Compatibility Review of Canterbury Crossing, a 34-lot single family subdivision.

Existing Conditions, Hudson GIS

Hudson Planning Commission	COMPATIBILITY REVIEW – CANTERBURY CROSSING
Case No. 2023-676	October 9, 2023

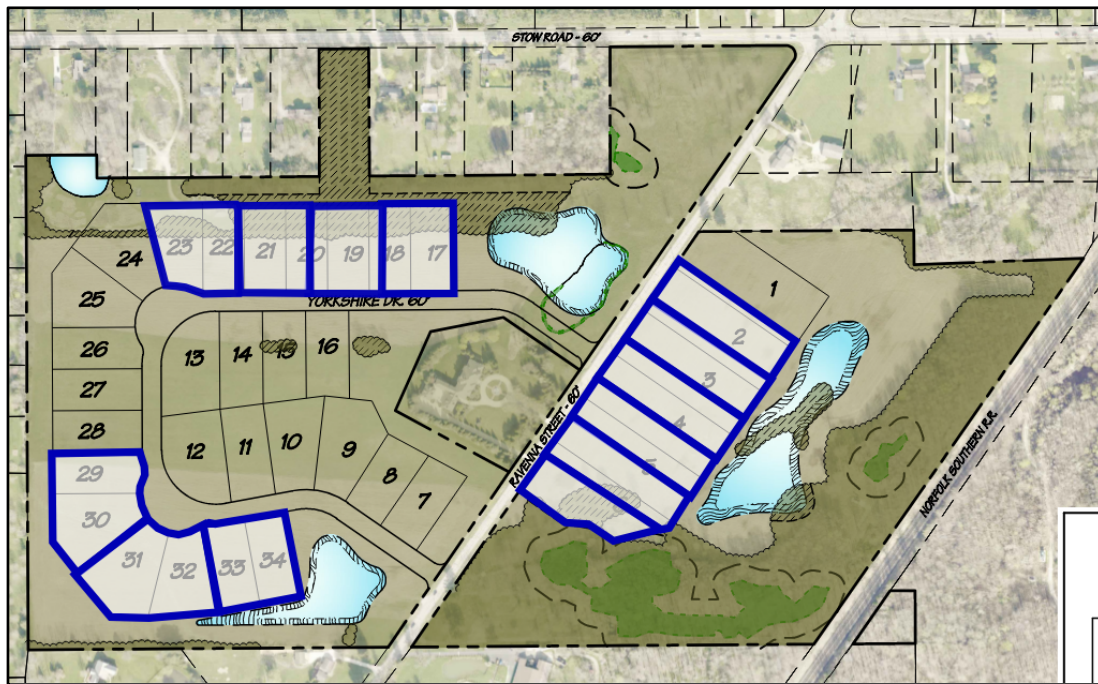
The applicant should reduce the overall number of units at the northern acreage and create a more compatible transition to the surrounding larger acreage lots to the north and south. This could be achieved by readjusting the lot lines as depicted in the accompanying figure. Staff notes an additional unit could be moved to the southern acreage by reducing the overall widths of the lots. The applicant could also study reducing the lot widths and sizes along the interior loop of the northern acreage

1. **Density/Compatibility:** Revise the layout so that the areas north and south of Ravenna Street more closely align with the maximum density requirement (one unit per 2.5 acres). Incorporate better transitions of lot sizes between the northern acreage and surrounding east/west development.

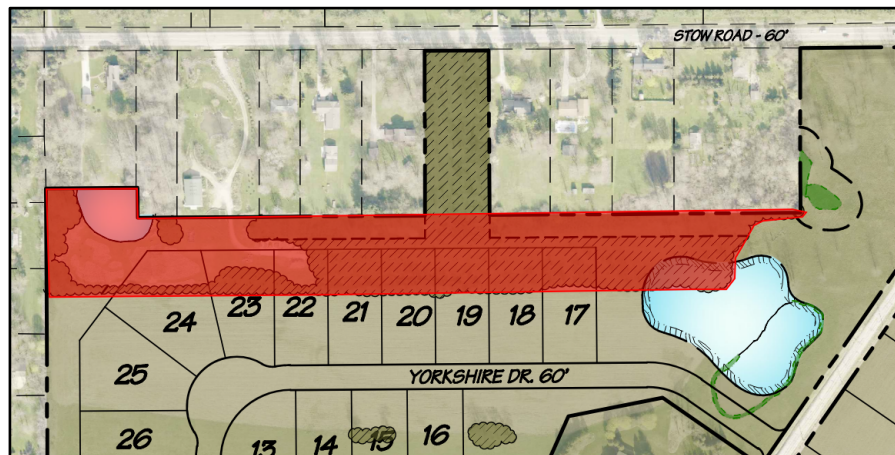
- The preliminary grading plan indicates a large area of existing trees would be removed and replanted (see figure below). Staff recommends this area be further studied as part of the preliminary subdivision application to inset the clearing limits for the preservation of trees and vegetation along the perimeter.

- d. Further study the area located at the rear yards of the adjacent Stow Road properties for preservation.
 - e. Professional determination of the potential drainage way at the northwest portion of the site.
